Information Note on the Decision Regarding the Request for Approval of Certified Emission Reductions for the

"NorthWind Bangui Bay Project" (0453)

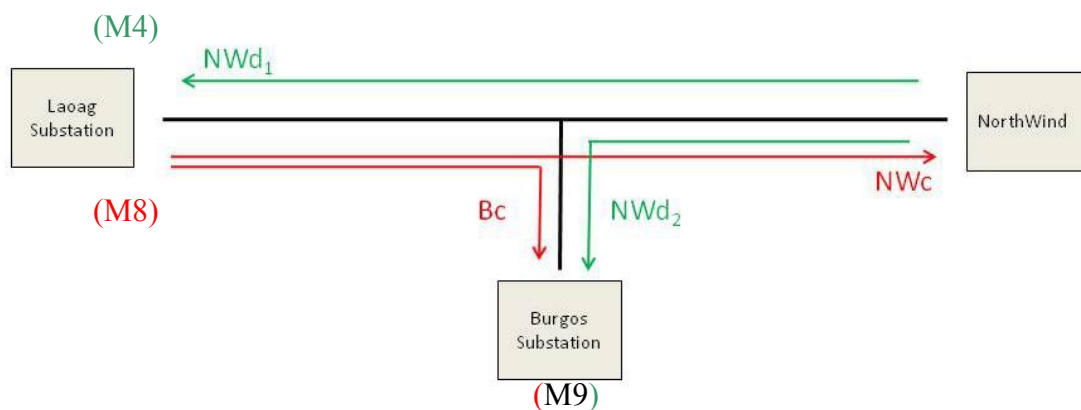
In response to the request for clarification, the DOE provided the below schematic, and verified that it represents the current metering schematic (since 14 November 2007). In the below schematic, meter M4 measures the amount of electricity delivered from NorthWind to the Laoag substation. Meter M8 measures the amount of electricity delivered from the Laoag substation to both the Burgos substation and Northwind. Meter M9 measures amount of electricity delivered to the Burgos substation from both the Laoag substation and Northwind.

Referring to the schematic, the DOE further verified that the below formula applies to determine the amount of electricity NorthWind exported to the grid:

$$NW_{grid} = NWd_1 + (NWd_2 + Bc) - (NWc + Bc)$$

Therefore, the DOE verified that measurements from meters M4, M8 and M9 can be used to determine the amount of electricity that NorthWind exported to the grid in accordance with the following formula:

$$NW_{grid} = M4 + M9 - M8$$

The monitoring report contains monthly summaries of electricity exported to the grid by NorthWind. However, the monitoring report does not state how the monthly summaries were determined or the information from which these monthly summaries were determined. No meter readings (i.e. M4, M8 and M9) are provided in the monitoring report. While these meters are depicted in the schematic contained in Annex 3 to the monitoring report, their type and their calibration records are not referenced in the monitoring report. It was considered that the monitoring report and other documentation does not sufficiently demonstrate in a clear and transparent manner how NorthWind determined (or how the DOE verified) the amount of electricity Northwind exported to the grid.

In addition, the formula provided above, as used by the NorthWind and verified by the DOE to calculate the amount electricity NorthWind exported to the grid, does not

take into account the amount of electricity imported from the grid to Northwind through the Burgos substation. It was considered that NorthWind did not state, and the DOE did not verify, that no electricity was imported from the grid through the Burgos substation to NorthWind.

- (a) It has not been sufficiently demonstrated:
 - (i) how the formulae used by the project participant in calculating the electricity supplied to the grid by the project activity has been correctly applied, i.e. readings of the three meters used (M4, M8, and M9) are not reflected on the monitoring report or spreadsheet; and
 - (ii) whether the calculation of electricity supplied takes into account all sources of electricity imports from the grid to the project activity via both substations;
- (b) The DOE failed to request for deviation or revision of the monitoring plan, since the actual monitoring practice is not in accordance with the monitoring plan, i.e. additional meters were installed while the original monitoring plan requires the monitoring of electricity supplied to the grid by project by direct measurement.
